944-SPEC - 944SPEC - low cost wheel to wheel racing

Posted by Sterling Doc - 17 Oct 2011 07:22

Re: 2012 Rules Change Requests Posted by phlip - 20 Oct 2011 04:07

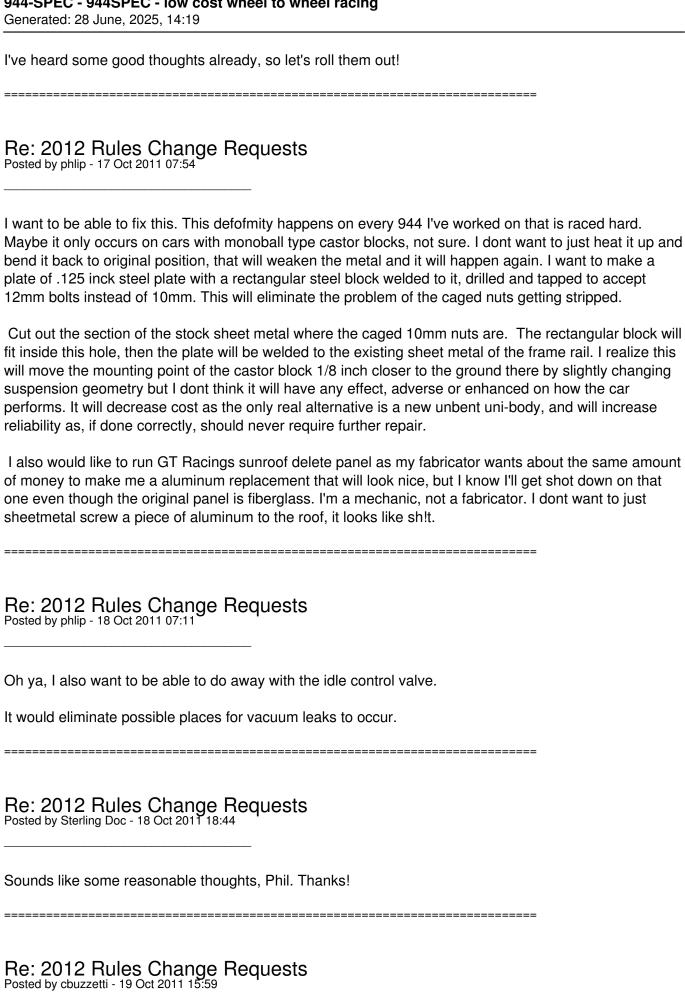
Not sure what to say about the pics above, if 1/8" closer to the ground will not make a difference then I dont see how 1/8" closer to the car will make any difference. It would be great to be able to fix that but it must be positioned in the same spot with the same sized hardware.

I dont care about the 1/8 inch, the bushing is twisted. It effects my ability to align the car properly, and its very difficult to get the caster block bolted backinto place if it has been removed for maintainance or repair, other spec series allow for repair and stregnthening of known weak points.
